Wylfa Newydd Project

Horizon's Response to IACC's Local Impact Report

PINS Reference Number: EN010007

18 December 2018

Figure 8-2 Homelessness in Sedgemoor¹⁹

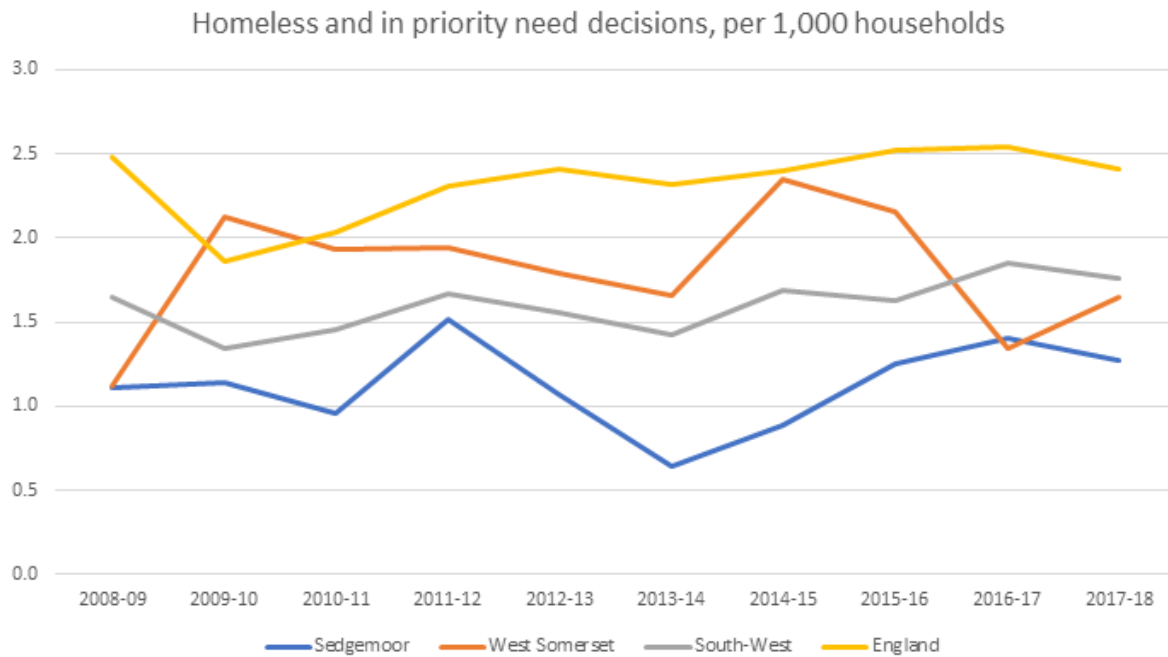
8.6.11 Figure 3 in chapter 8, LIR is described in paragraph 5.11.1 as showing a 128% increase in priority homeless numbers in Sedgemoor. However this is a selective comparison of two data points on a data series this is naturally erratic at a local level such as this. A longer time series, as in Figure 3-2 below, shows that the rate has remained low, with no clear upwards trend since the start of the main construction programme in 2016.

Figure 8-3 House prices in Somerset

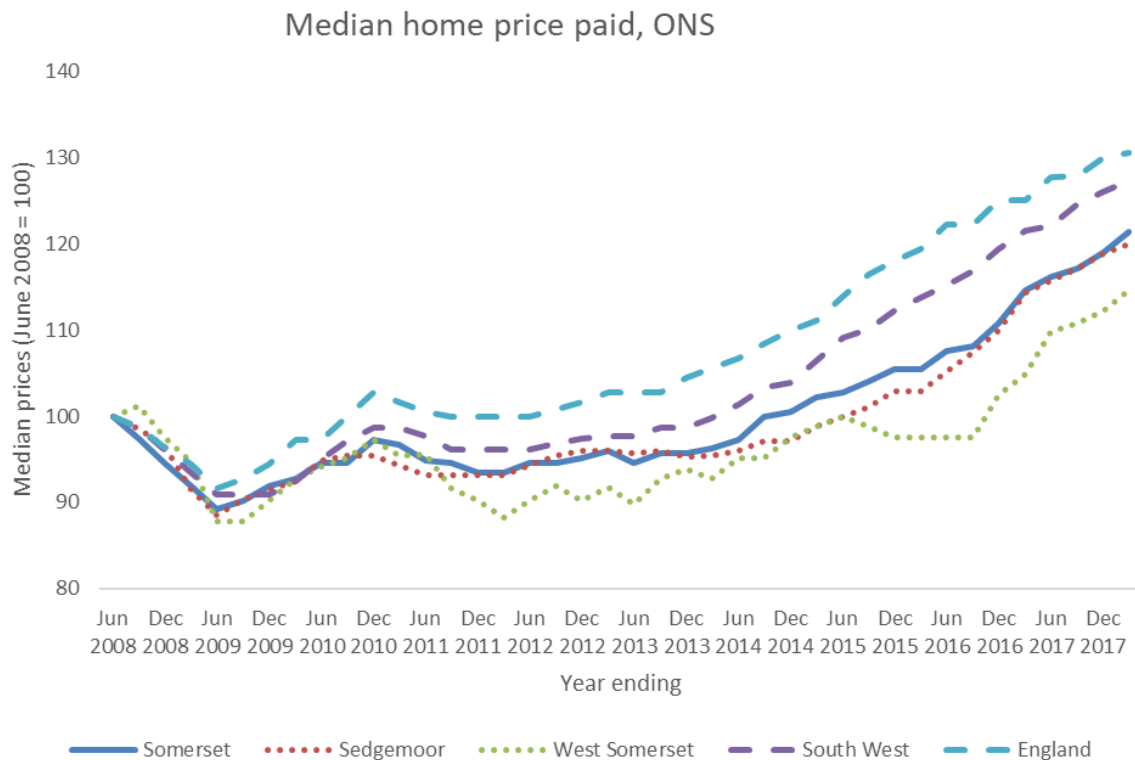
8.6.12 Similarly, paragraph 5.22.2 of chapter 8, referring to Figure 9, states that house prices in Sedgemoor have increased faster than the average for Somerset. There are a variety of official or commercially produced house price indices, and the LIR provides no source reference for the data presented, nor is it clear whether it refers to mean or median averages.

8.6.13 Median prices are generally considered a better measure of house prices, because they avoid distortion by small numbers of sales at either extreme of the price range. Figure 2-3 below shows the official ONS median price paid for homes, rebased to the peak of the market in June 2008 to show relative changes over this house price cycle.

8.6.14 While data for smaller areas is naturally more erratic, it shows that Sedgemoor prices have broadly tracked the average for Somerset County while West Somerset prices have continued to lag the rest of the County. In both cases house prices have risen more slowly than the regional or national average, with no clear divergence in prices during the Hinkley Point C construction period.

Figure 10-1 Horizon A55 Junction 3 scheme development showing proposed shared footway / cycleway (extract from drawing number WN0902-HZDCO-OHW-DRG-00002 Rev 1.0)

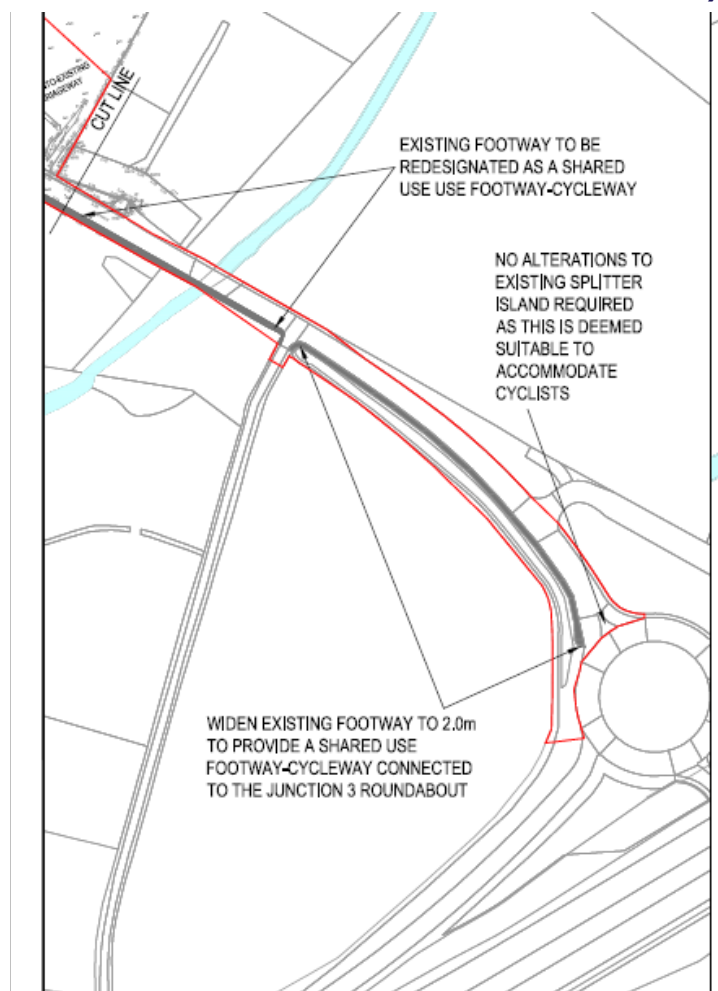
10.16.1 Refers to section 6.3.3.

10.16.2 Horizon's latest iteration of the scheme design includes a shared footway / cycleway between the new roundabout and junction 3 of the A55. Horizon notes that IACC Highways have been part of the design team and development of this scheme.

Figure 12-1 Additional sensitive receptors

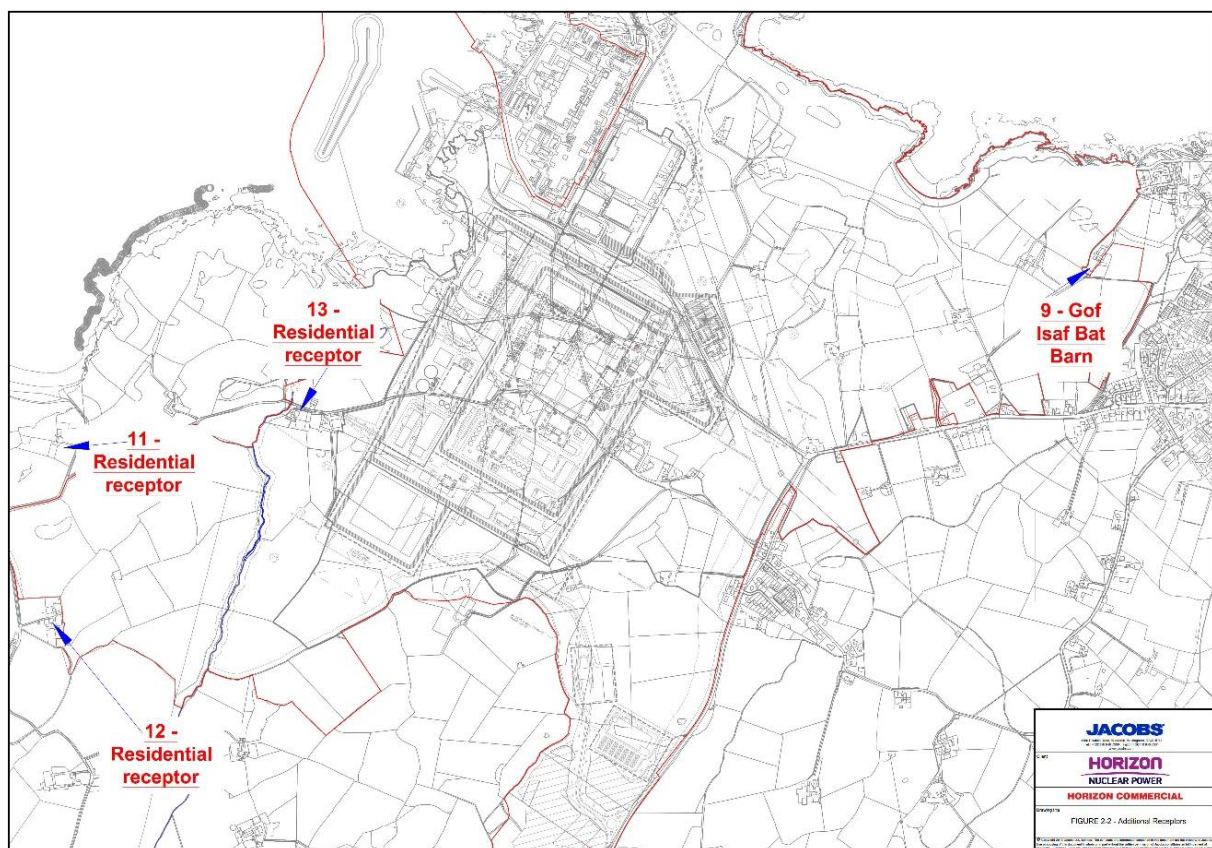
- 12.3.2 At the time the ELIA [APP-201] was undertaken access to private properties and land parcels was declined. This was highlighted in the ELIA Limitations section 1.3.33, and that other sources of information (aerial imagery and mapping) have been used to make assumptions on topography and other natural screening present.

- 12.3.3 Since completing the ELIA an additional four sensitive receptors have been identified that could potentially be affected by artificial lighting from the proposed Wylfa Newydd DCO Project site during construction. These are the Gof Isaf bat barn (Receptor 9), which is an ecological receptor, and three residential receptors. These residential receptors are located on the western boundary of the Wylfa Newydd Development Area (Receptor 11, 12 and 13).

- 12.3.4 The lighting modelling showed no significant effects on these residential receptors 12 and 13. A medium adverse magnitude of effect was identified at
